**Bulletin Number:** TB-250401

**Subject:** [P65D-X389](#) Operating Switch Upgrade For [PH25AG](#) & [PH55AG](#) Heater Kits

**Issue Date:** April 30, 2025 (Update June 6, 2025)

Instructions to connect P65D-X389 Operating Switch into First Generation P25A Heater Harness

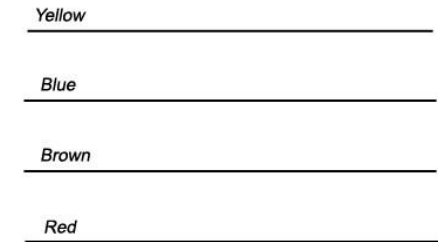
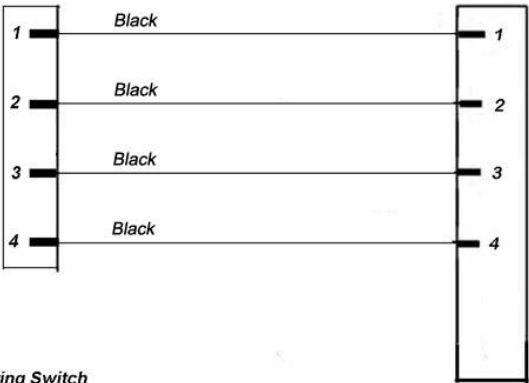
The P65D-X389 operating switch will work with First Generation Heaters  
However, wiring connectors do not match up.  
Simply remove existing connector from switch harness and connect as shown.  
Use suitable butt connectors to make connections shown.
